MASTER PLAN DESIGN REGULATIONS
~~2025~~September 8, 2025

MASTER PLAN DESIGN REGULATIONS
2025September 8, 2025

~~AMENDED~~ TREE DISPOSITION AND MITIGATION PLAN

EXHIBIT F ~~AMENDED~~ LANDSCAPE PHASING PLAN

POWER LINE MODIFICATION PLAN

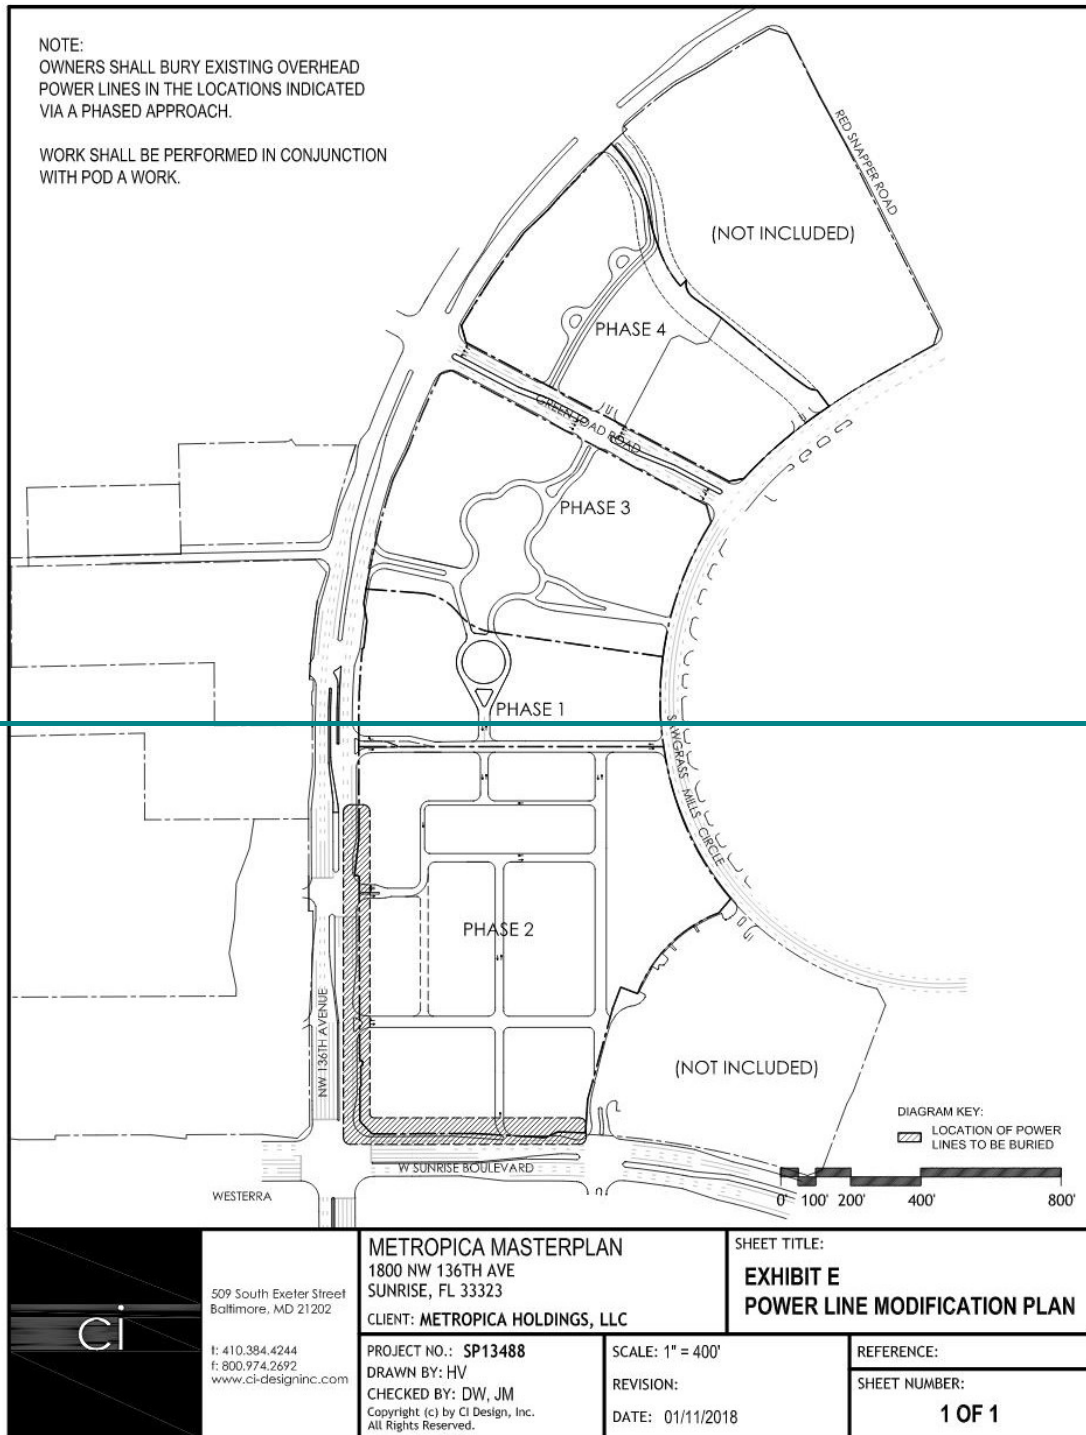
NOTE:
OWNERS SHALL BURY EXISTING OVERHEAD
POWER LINES IN THE LOCATIONS INDICATED
VIA A PHASED APPROACH.

WORK SHALL BE PERFORMED IN CONJUNCTION
WITH POD A WORK.

SHEET TITLE:
**EXHIBIT F - AMENDED
LANDSCAPE PHASING PLAN**

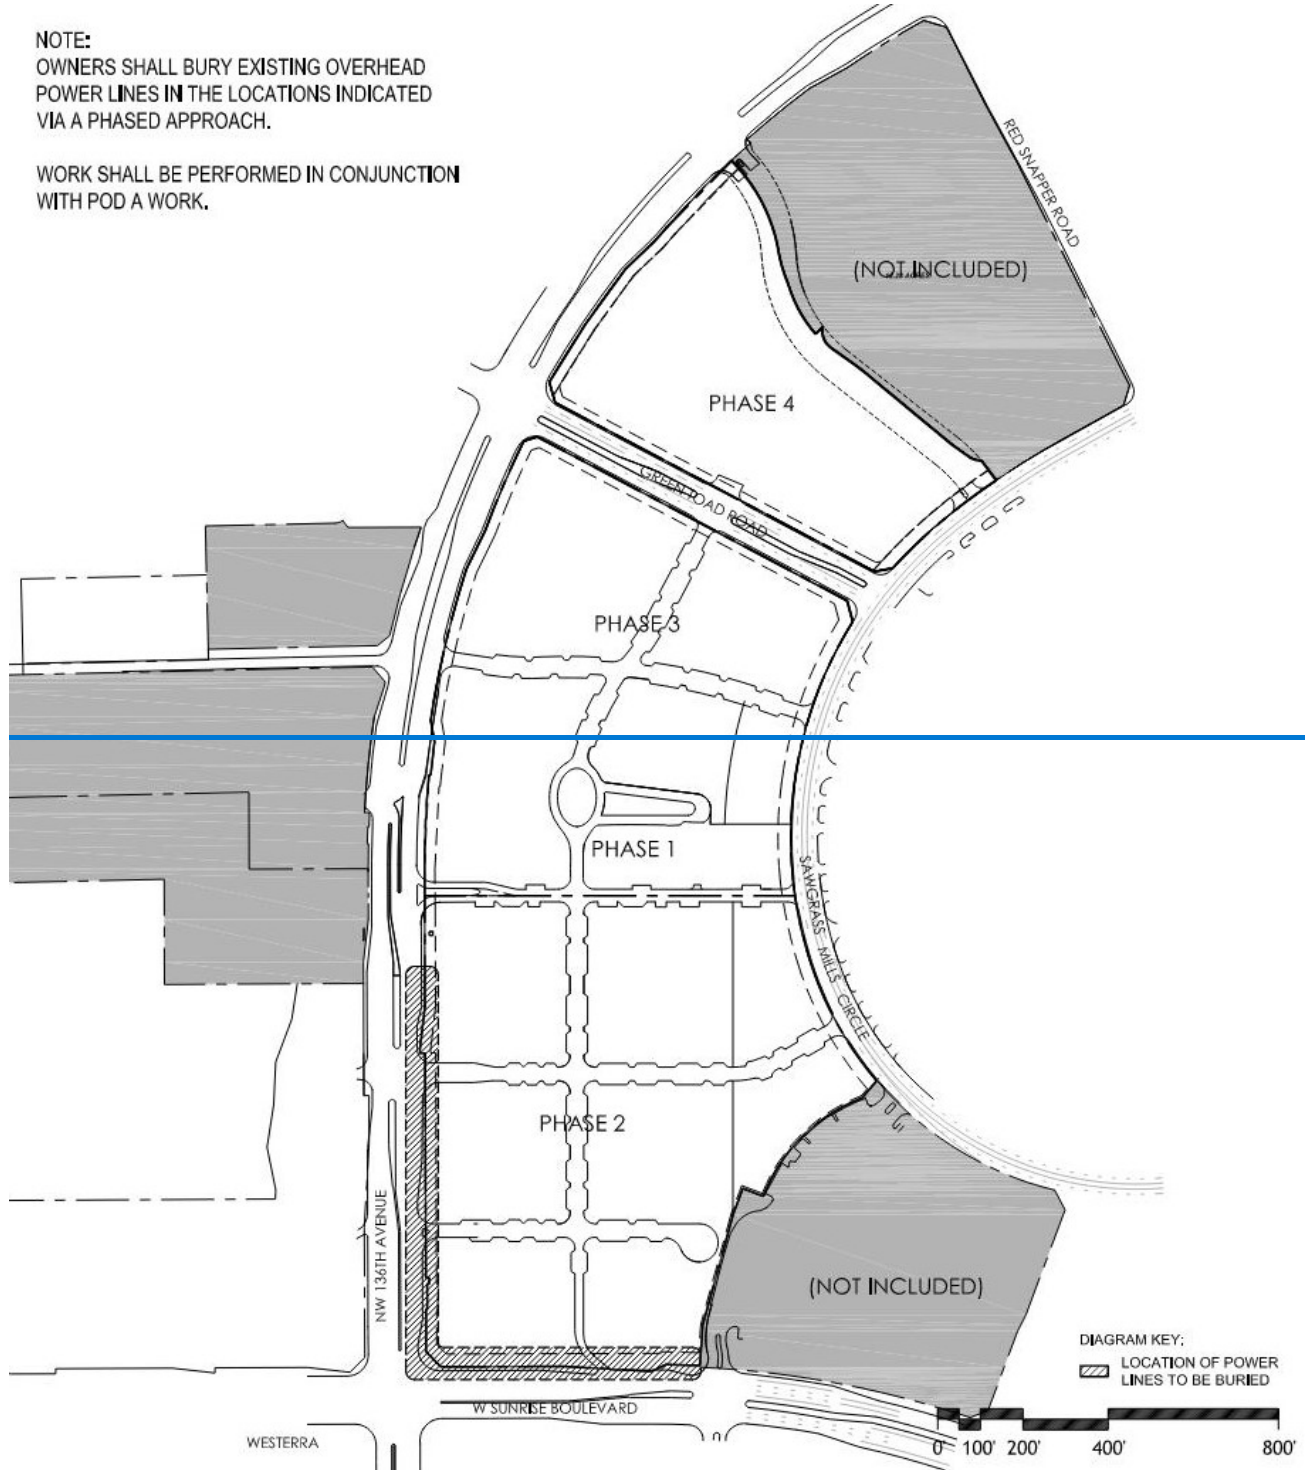
E	RESIDENTIAL AREA / FUTURE CONSERVATION AREA - POD B4		* PHASING SUBJECT TO CHANGE
	THIS AREA IS ENCUMBERED UPON WITH A CONSERVATION EASEMENT. THIS AREA WILL BE DESIGNED & DEVELOPED UPON AGREEMENTS WITH THE CITY, RELEASE OF THE EASEMENT & SATISFACTION OF THE SITE WETLAND MITIGATION.		
F	RESIDENTIAL AREA - POD B5		
	PHASE F OF THE PERIMETER LANDSCAPE WILL BE A CONTINUATION OF PHASE C ALONG NW 136TH AVENUE OUTSIDE OF THE EXISTING CONSERVATION EASEMENT. PHASE F PERIMETER LANDSCAPE WILL OCCUR ALONG THE NW 136TH AVENUE CORRIDOR & CORRELATE TO THE METROPICA REAL ESTATE SALES FACILITY LANDSCAPE STRATEGY.

AMENDED OFF-SITE IMPROVEMENTS PLAN

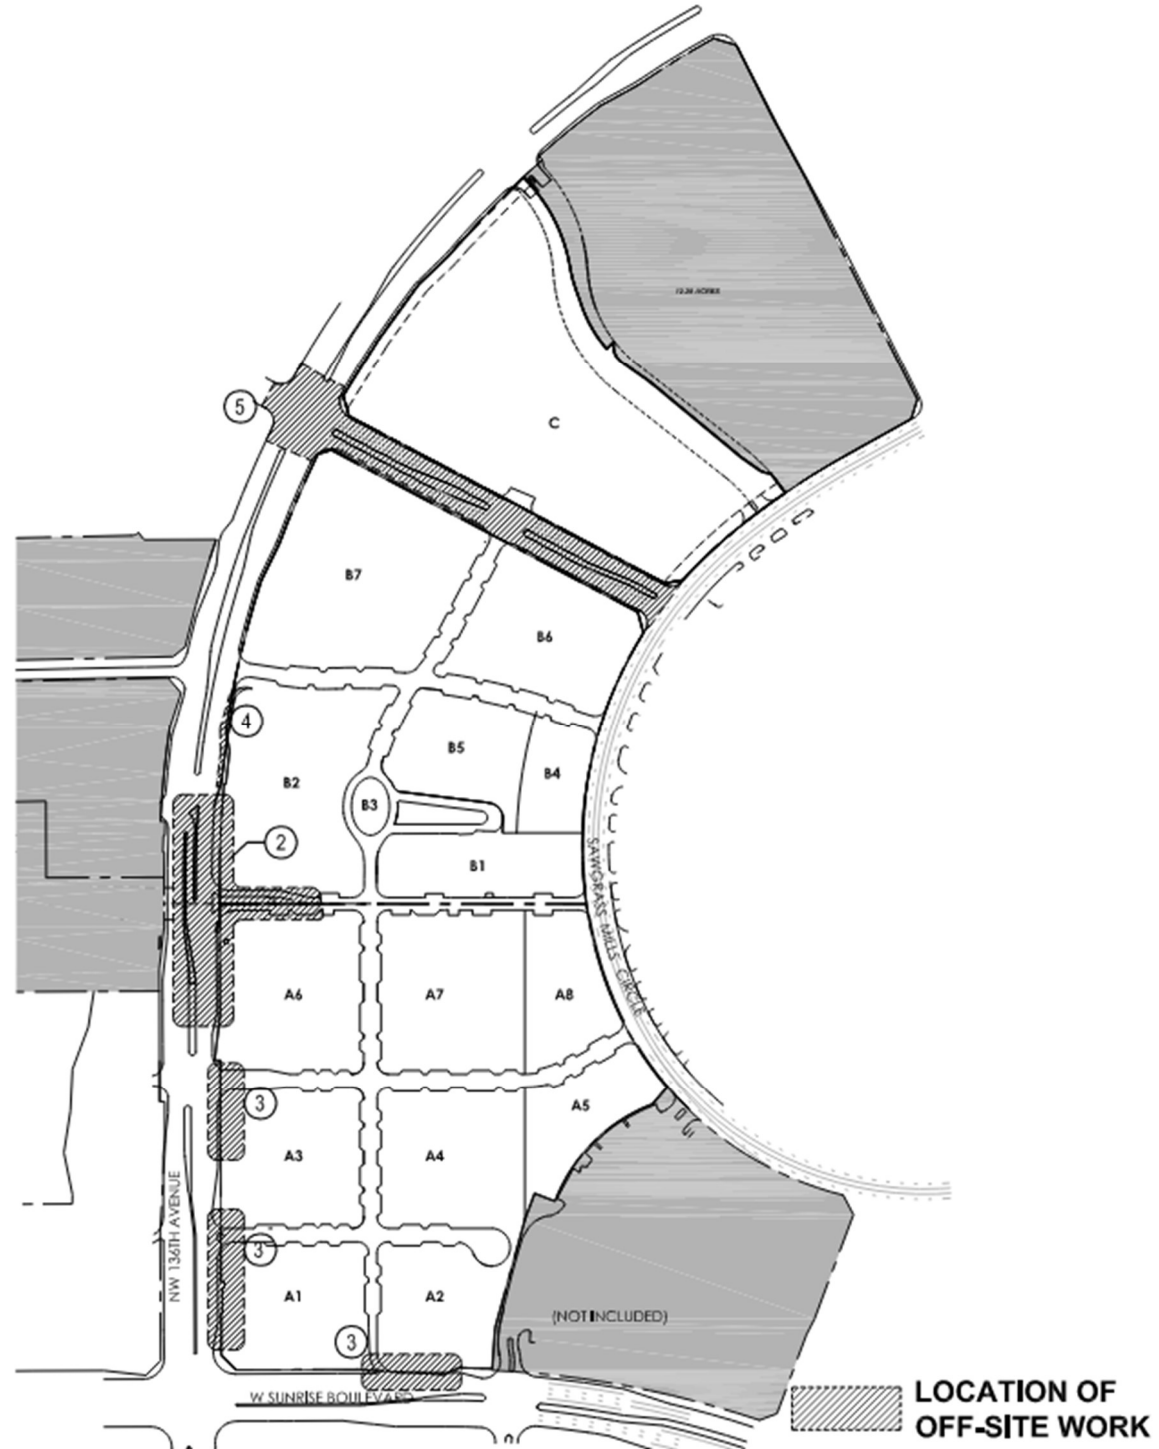
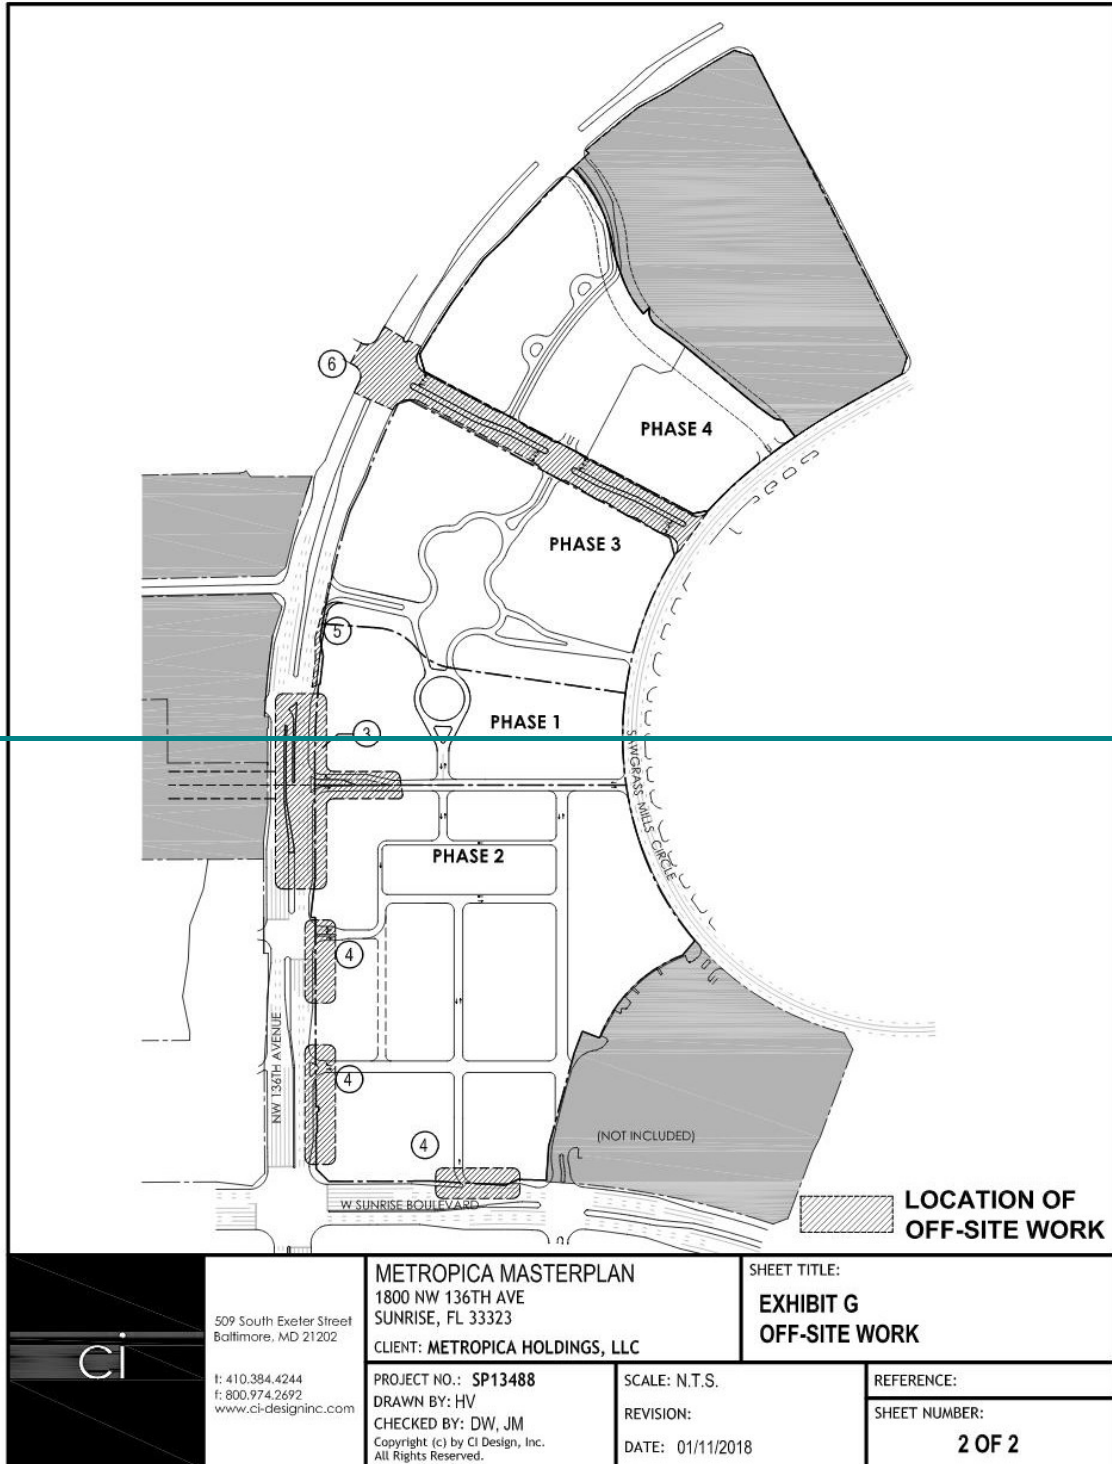
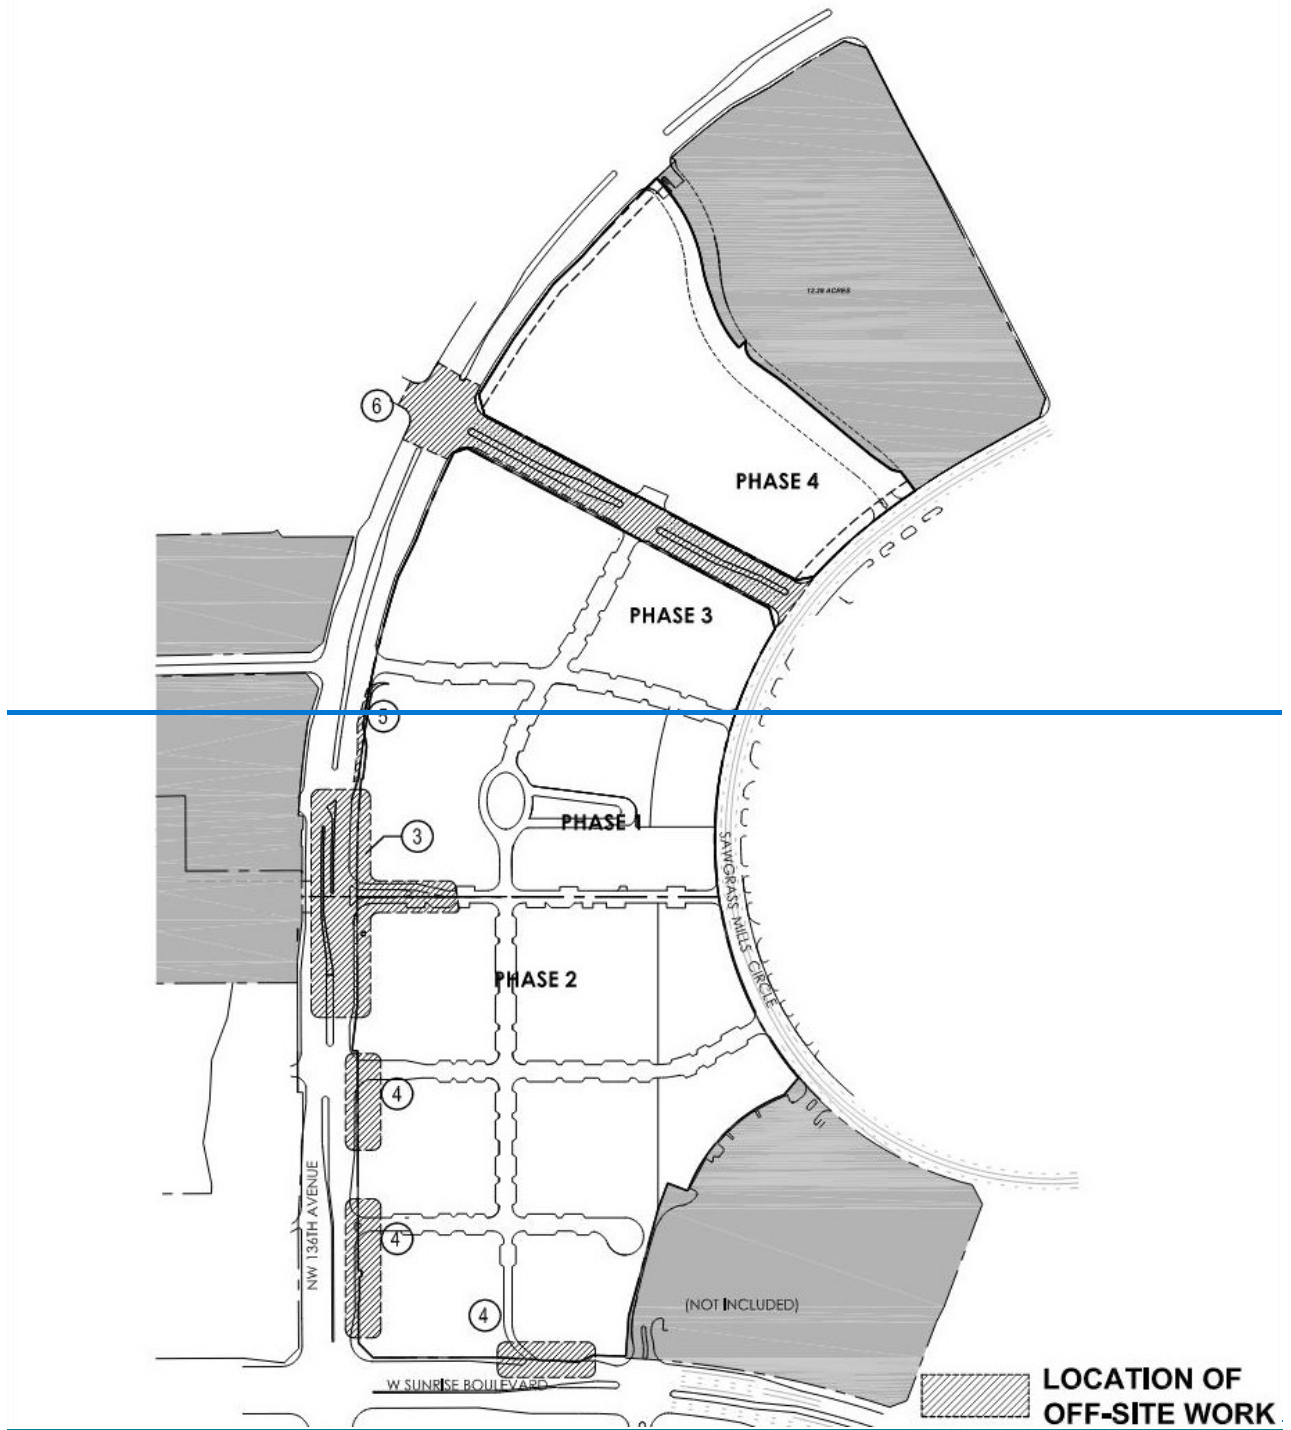
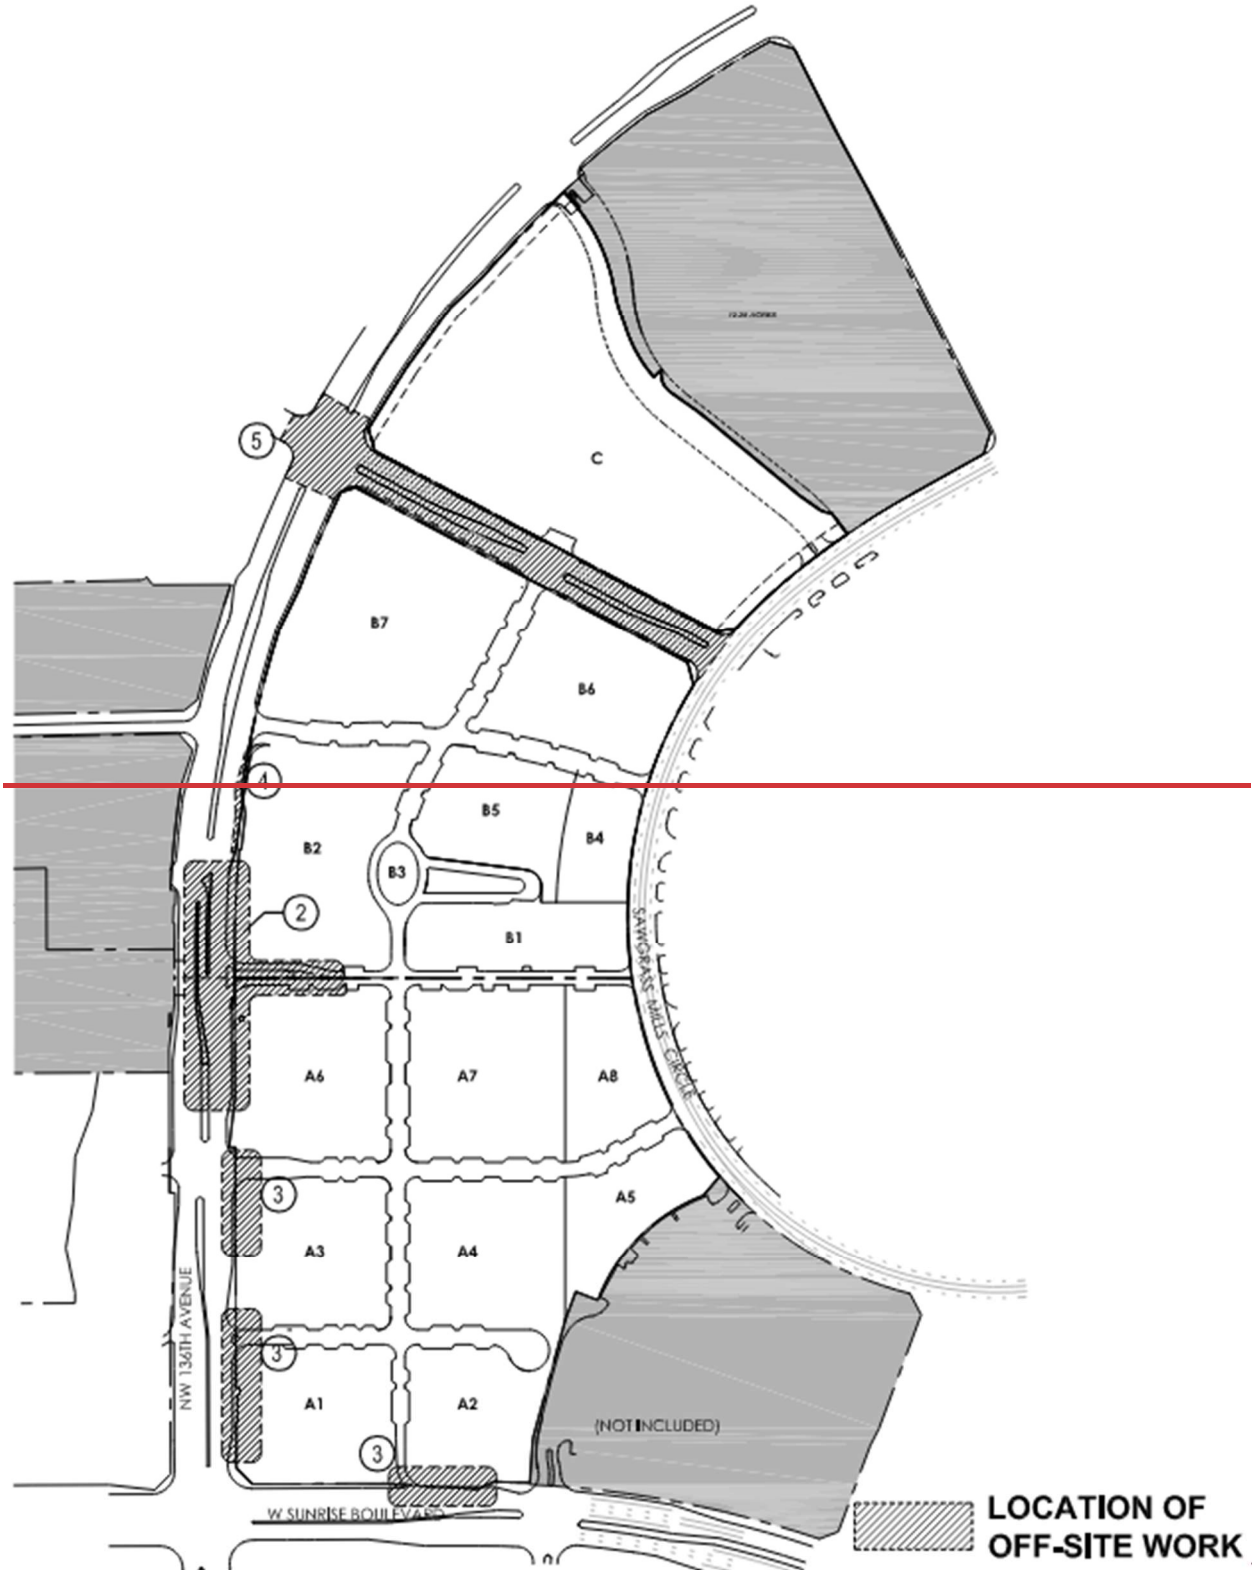
- ① TRANSIT STATION IN THE TIME AND MANNER DESCRIBED IN THE DRI
- ② SR-84 IMPROVEMENTS IN THE TIME AND MANNER DESCRIBED IN THE DRI. (COMPLETED)
- ③ TURN LANE AND MEDIAN MODIFICATIONS ASSOCIATED WITH EAST-WEST CONNECTOR, PRIOR TO C.O. FOR PHASE I.
- ④ TURN LANE AND ACCESS MODIFICATIONS ASSOCIATED WITH PHASE 2 PRIOR TO ISSUANCE OF C.O. FOR BUILDINGS ON PHASE 2.
- ⑤ TURN LANE AND ACCESS MODIFICATIONS ASSOCIATED WITH PHASE 3 PRIOR TO ISSUANCE OF C.O. FOR BUILDINGS ON PHASE 3.
- ⑥ ACCESS AND MEDIAN MODIFICATIONS AT GREEN TOAD ROAD

- ① SR-84 IMPROVEMENTS IN THE TIME AND MANNER DESCRIBED IN THE DRI. (COMPLETED)
- ② TURN LANE AND MEDIAN MODIFICATIONS ASSOCIATED WITH EAST-WEST CONNECTOR, PRIOR TO C.O. ■ **COMPLETED**
- ③ TURN LANE AND ACCESS MODIFICATIONS ASSOCIATED WITH PARCEL A PRIOR TO ISSUANCE OF C.O. FOR BUILDINGS ON PARCEL A.
- ④ TURN LANE AND ACCESS MODIFICATIONS ASSOCIATED WITH PARCEL B PRIOR TO ISSUANCE OF C.O. FOR BUILDINGS ON PARCEL B
- ⑤ ACCESS AND MEDIAN MODIFICATIONS AT GREEN TOAD ROAD PER DEVELOPMENT OF REGIONAL IMPACT ORDER

- ① SR-84 IMPROVEMENTS IN THE TIME AND MANNER DESCRIBED IN THE DRI. (COMPLETED)
- ② TURN LANE AND MEDIAN MODIFICATIONS ASSOCIATED WITH EAST-WEST CONNECTOR, PRIOR TO C.O. - **COMPLETED**
- ③ TURN LANE AND ACCESS MODIFICATIONS ASSOCIATED WITH PARCEL A PRIOR TO ISSUANCE OF C.O. FOR BUILDINGS ON PARCEL A.
- ④ TURN LANE AND ACCESS MODIFICATIONS ASSOCIATED WITH PARCEL B PRIOR TO ISSUANCE OF C.O. FOR BUILDINGS ON PARCEL B
- ⑤ ACCESS AND MEDIAN MODIFICATIONS AT GREEN TOAD ROAD PER DEVELOPMENT OF REGIONAL IMPACT ORDER
- ⑥ THE OWNERS HEREBY COMMIT TO INSTALL FUTURE OFFSITE IMPROVEMENTS FOR ACCESS AND DRIVEWAYS NECESSARY TO ENSURE CONNECTIVITY WITH ADJACENT ROADWAYS AND PROPERTIES AS SUCH CONNECTION POINTS BECOME AVAILABLE.
